RE: Elm Terrace Parking Lot and Walkway Upgrade Project
Notice of Intent

GCG Associates, Inc., on behalf of the North Attleborough Housing Authority has updated our plans to reflect comments and discussion from the recent hearings. The following revisions have been made to the plans.

SITE PLAN REVIEW FOR (NAHA)
NORTH ATTLEBOROUGH HOUSING AUTHORITY
100% CONSTRUCTION DOCUMENTS

REVISED JANUARY 28, 2026
DECEMBER 18, 2025

**SITE PLAN**  
**ELM TERRACE (667-2)**  
**PARKING LOT & WALKWAY UPGRADES**  
**NORTH ATTLEBOROUGH HOUSING AUTHORITY**  
**NORTH ATTLEBOROUGH, MASSACHUSETTS**

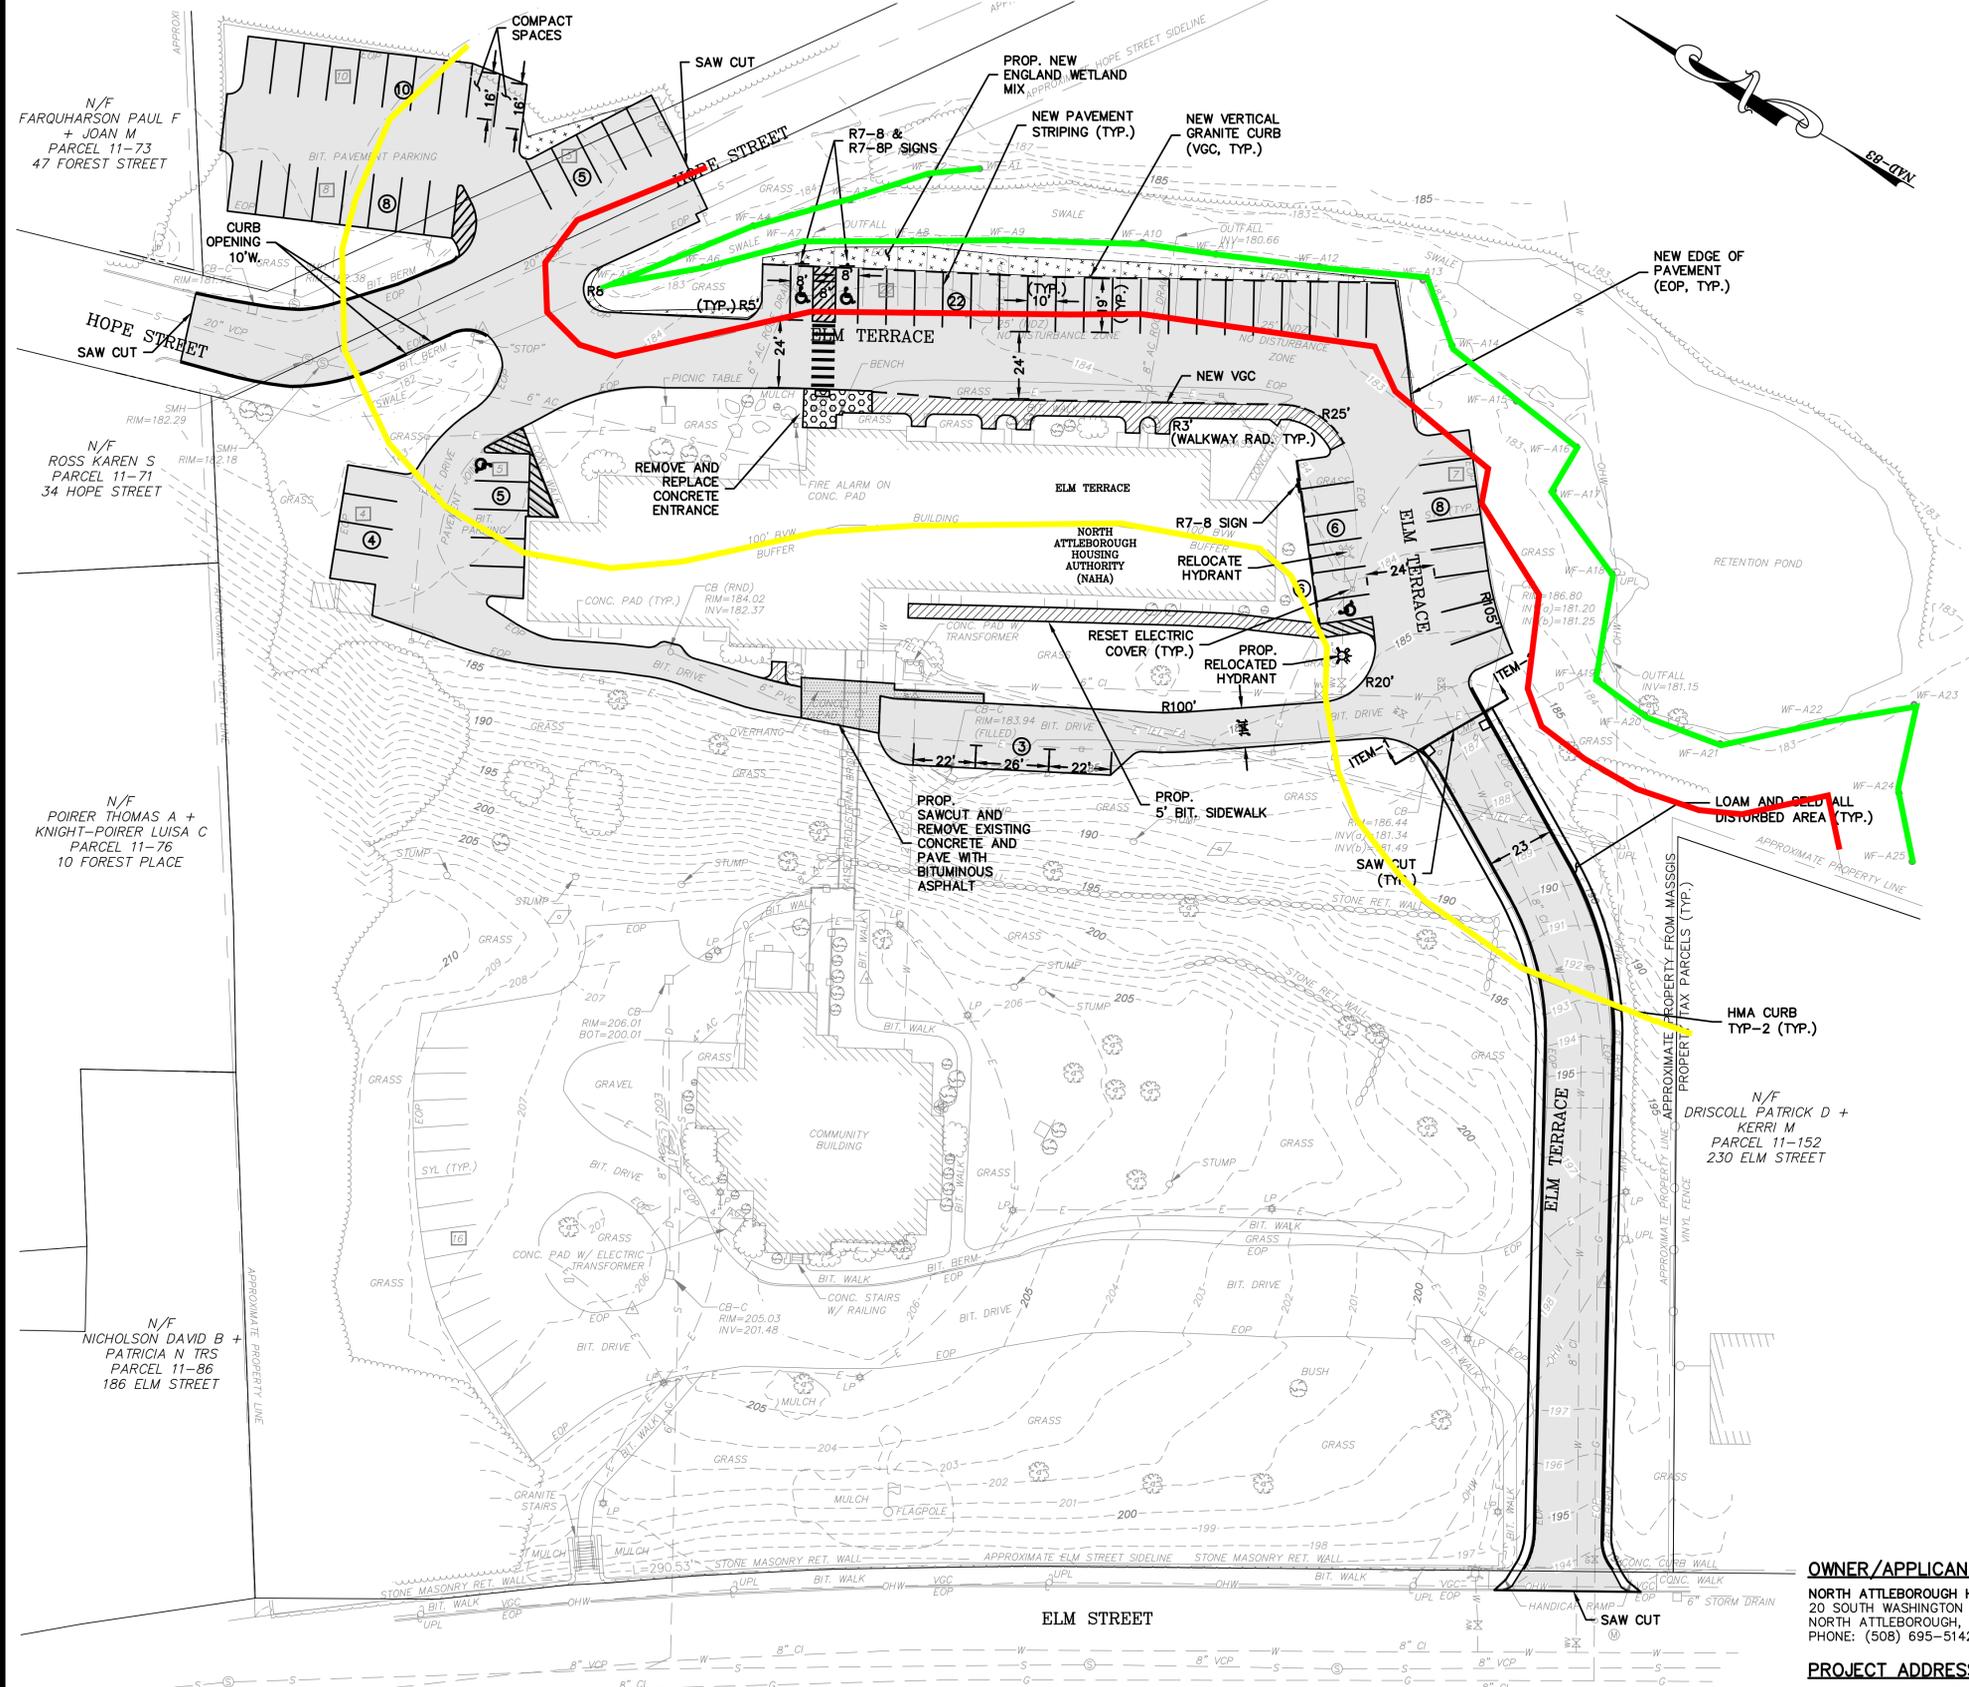
- The travel way along the front of the building that runs parallel with the drainage swale has been reduced by 4.5 feet from 28.5 feet to a 24-foot travel way which moved the new granite curbing further back from the swale. This adjustment moves the current edge of pavement back 3' to 8.5' further back away from the wetlands. The granite curbing along the parking lot prevents sediment and runoff from directly flowing into the swale/wetland as it does now. The runoff flows parallel to the swale then over land across grass and eventually into the resource areas. We have also reduced the width of the entry way to the site from 24 feet wide to 23 feet wide (approximately 300 feet of roadway).

- The overall impervious surface inside the 100-foot buffer zone is reduced by 272 square feet. The movement of the parking area further away from the wetland resource area offsets the seven new spaces at the end of the building. The net change in impervious surfaces is 5 square feet less over the entire site.

**GRADING PLAN**  
**ELM TERRACE (667-2)**  
**PARKING LOT & WALKWAY UPGRADES**  
**NORTH ATTLEBOROUGH HOUSING AUTHORITY**  
**NORTH ATTLEBOROUGH, MASSACHUSETTS**

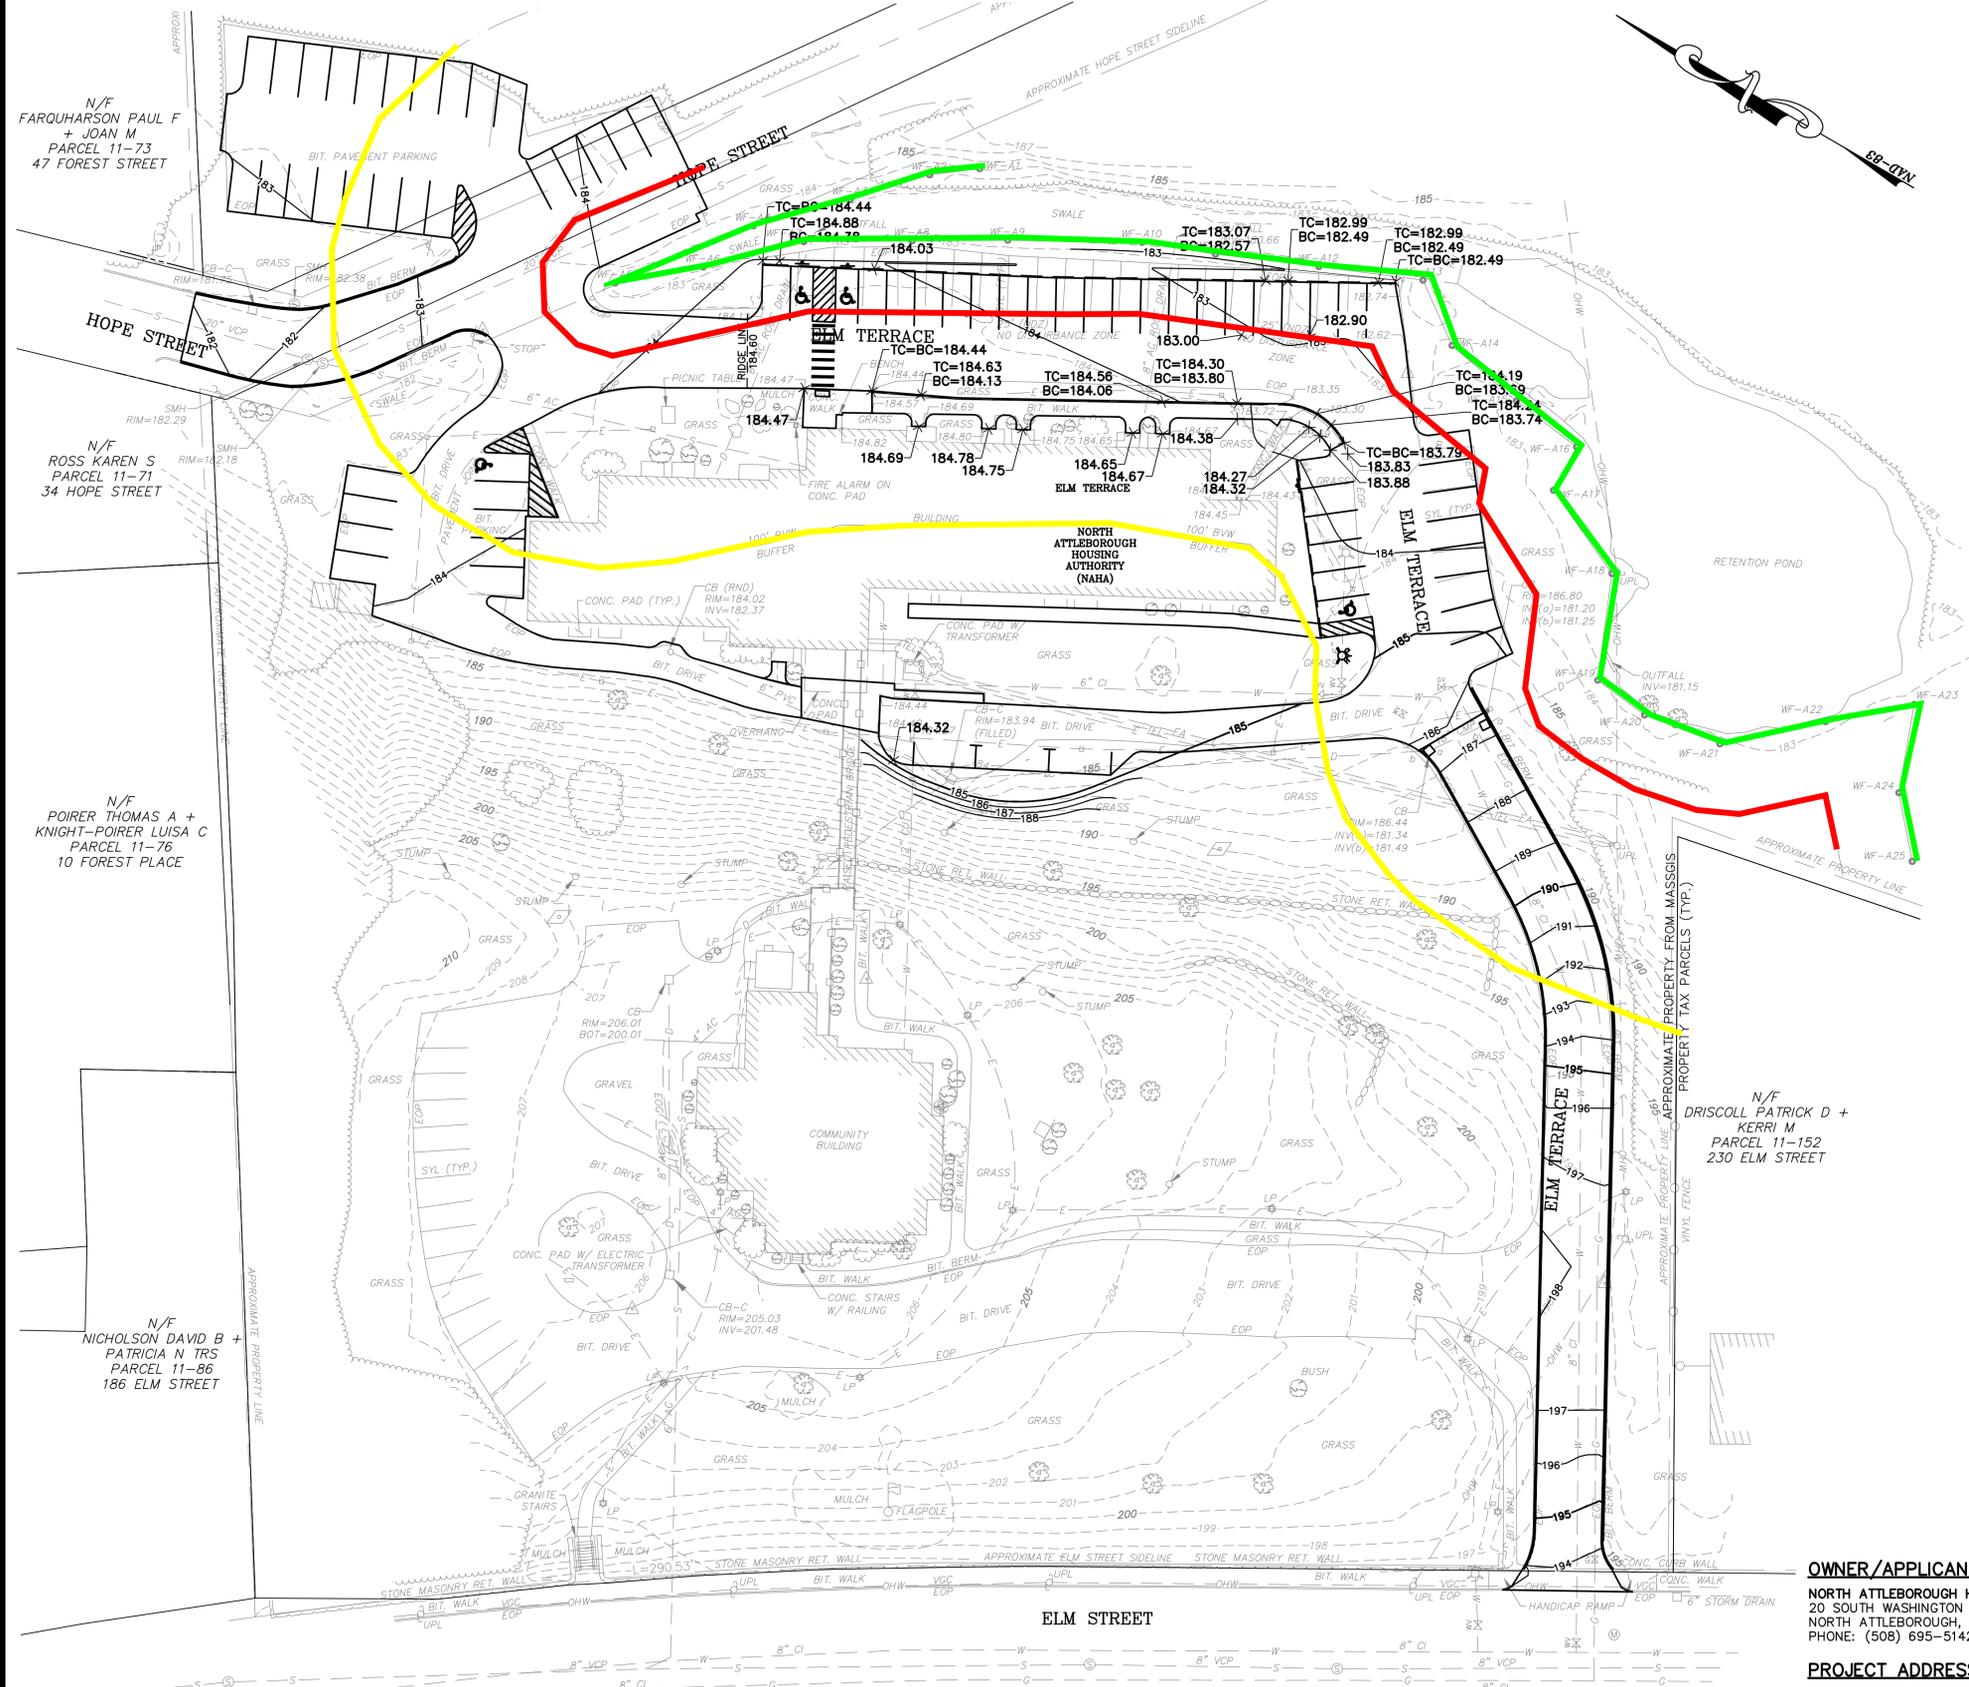
- The slope between the parking and the resource area will be graded and have a New England Wetland Mix place on the slope.
- All culverts and drain lines will be jetted, cleaned and video inspected during the construction to make sure there is not a need for placement.
